NOTE: IT IS RECOMMENDED THAT THE CHOKE LINE BE ATTACHED  
ABOVE THE BOTTOM PREVENTER

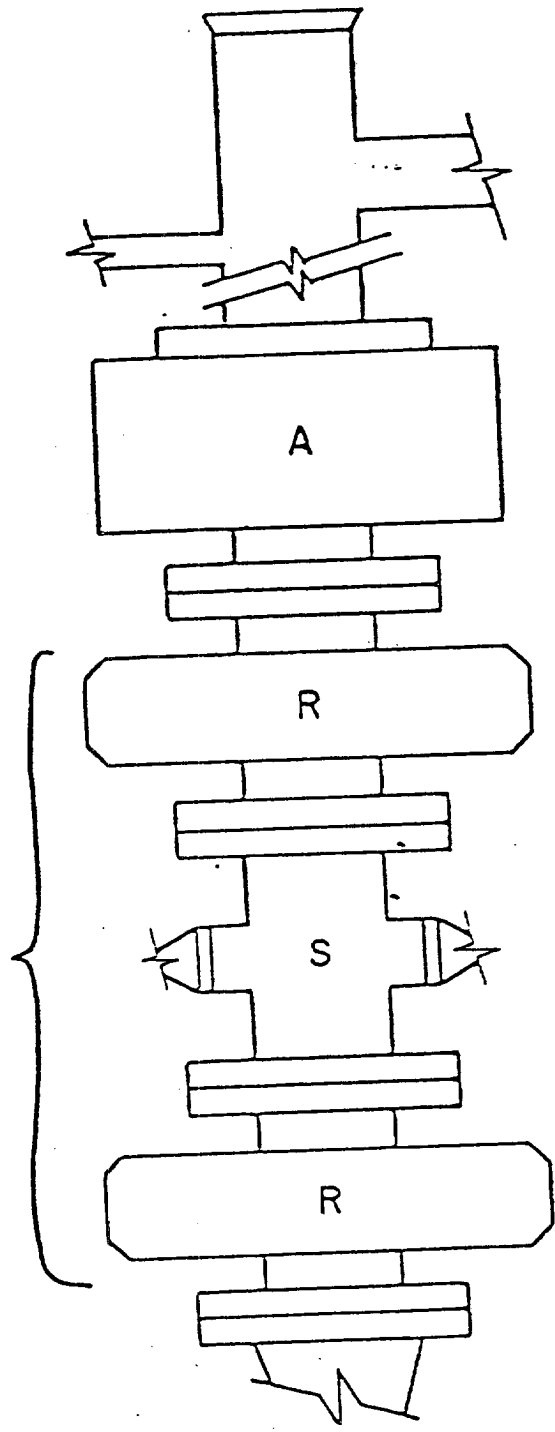
This may be a double  
with a side outlet
